ASSESSMENT REPORT

Section 75W Modification – Used Oil Transfer Station, St Marys

Figure 3: Proposed Modified Site Layout

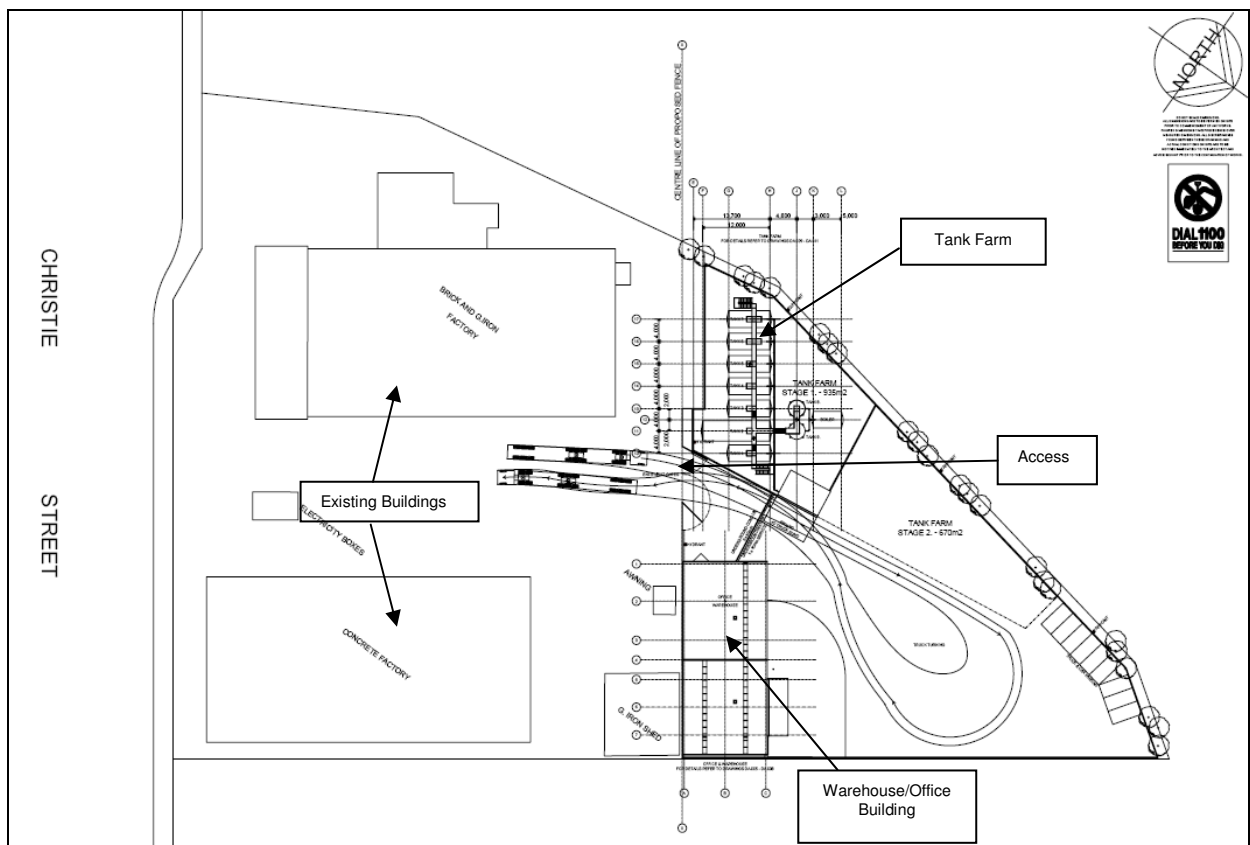
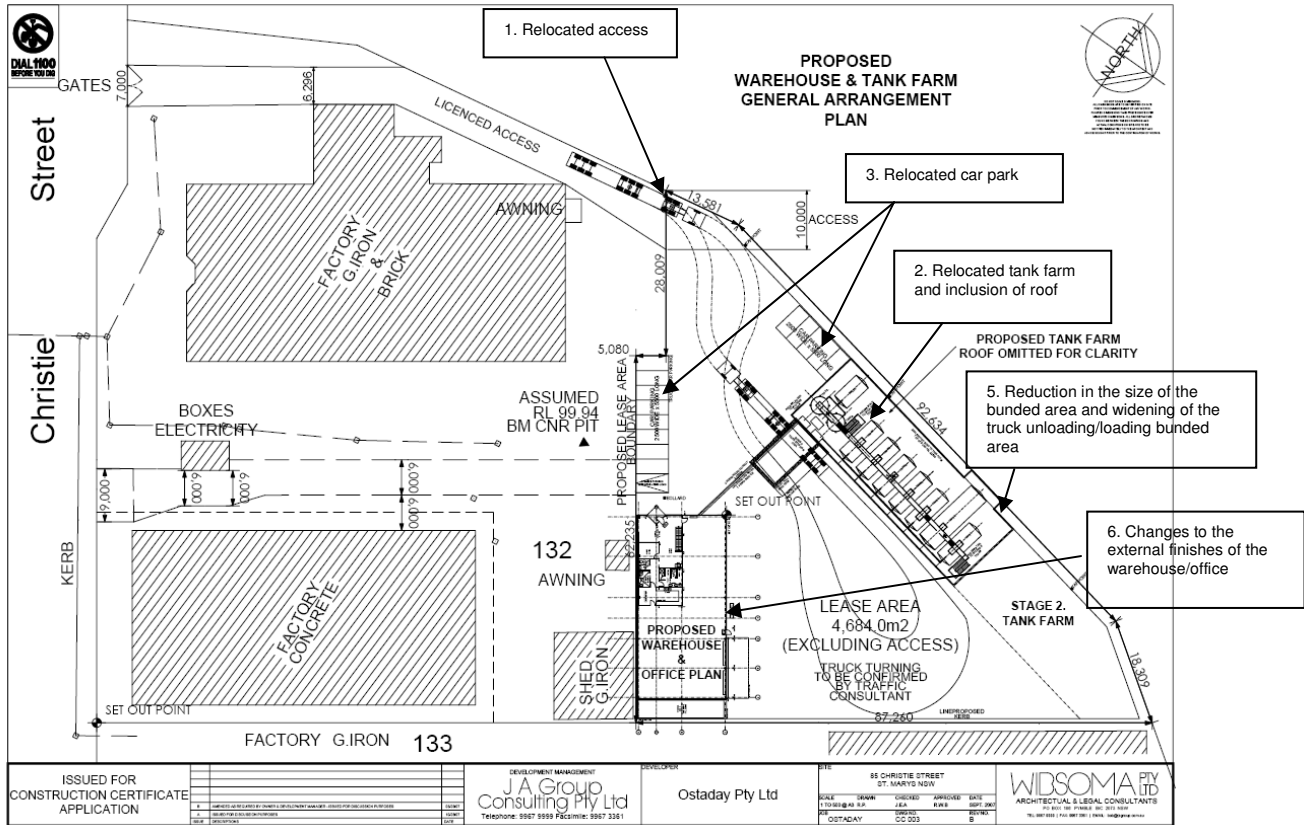
SOC lease the northern portion of the site (see Figure 2). The owner of the site has requested that SOC relocate the proposed access from the centre of the site to the west of the site to reduce conflicts between vehicles and pedestrians on the entire site. To accommodate this change, SOC has been required to rearrange other structures on site.

- 1) relocation of the proposed access from the centre of the site to the west of the site. The access would also be widened from approximately 9m to 10m;
- 2) relocation of the tank farm to the northern boundary of the site, inclusion of a roof over the tank farm and the provision of a wider loading/unloading bunded area;
- 3) relocation of the carpark from the northern boundary of the site. Two parking areas are proposed – 9 spaces adjacent to the warehouse/office building and 5 spaces located adjacent to the southern side of the tank farm;
- 4) minor changes to the design (pipe size and pipeline location) of the stormwater management system;
- 5) reduction in the size of the bunded area for the tanks; and
- 6) changes to the external finish of the warehouse/office from metal cladding to painted concrete panelling.

The distance between the tank farm and other surrounding buildings including the proposed warehouse/office building exceeds 15 metres, and therefore complies with AS 1940. The Department notes that the closest residences are located approximately 800m from the site.

AS 1940 requires the capacity of the bunded area to be at least the capacity of the largest tank, or for this facility, 120,000L. The capacity of the bunded area for the approved tank farm was 540,000L. SOC propose to reduce the capacity of the bunded area from 540,000L to 308,000L. However, the proposed capacity of the bund would still be considerably greater than that required by AS 1940. The capacity of the bunded area for the unloading/loading facility also exceeds the requirements of AS 1940. The Department is therefore satisfied that the bunding proposed is more than adequate to contain any spills on site, and that the reduction in the bunding capacity would not increase the risks of the project. Additionally, the existing conditions of approval would adequately manage hazard and risk issues for the amended proposal.

The Department considers that no adverse visual impacts would arise from the proposal to modify the external finish of the warehouse/office building (from metal cladding to painted concrete panelling), to relocate the tank farm and the addition of a roof structure over the tank farm. This is primarily due to the industrial nature of the site and surrounding land uses, as well as the distance to residential areas. Additionally, the size and height of the warehouse/office building and the tank farm would not be altered.

No detailed plans of the new roof structure have been provided. As such, the Department has recommended that SOC be required to submit detailed plans of the new roof structure for approval, prior to the commencement of construction. The recommended condition also requires that the plans be prepared in consultation with Penrith City Council (Council) to ensure any requirements of Council are incorporated into the design of the roof structure.

The relocation of the access to the facility requires a new access off Christie Street. SOC is also proposing to install gates at this access. The Department has recommended that the driveway be designed and constructed in accordance to Australian Standard AS 2890.2-2002: *Parking facilities - Off-street commercial vehicle facilities*, and any requirements of Council.

The relocation of the access has also resulted in the relocation of other components on site including the car parking area. SOC is proposing to increase the number of car/truck parking spaces from 9 to 14. The number of parking spaces meets Council's requirements for industrial land, and the Department is satisfied that adequate parking has been provided.

The proposed modification has also resulted in a minor realignment of the truck turning area, however, sufficient area has been provided to allow vehicles to enter/exit the site in a forward direction. The Department is satisfied that SOC has provided sufficient measures to minimise the potential for traffic accidents, and the relocation of the access would resolve conflicts between pedestrians and vehicles.
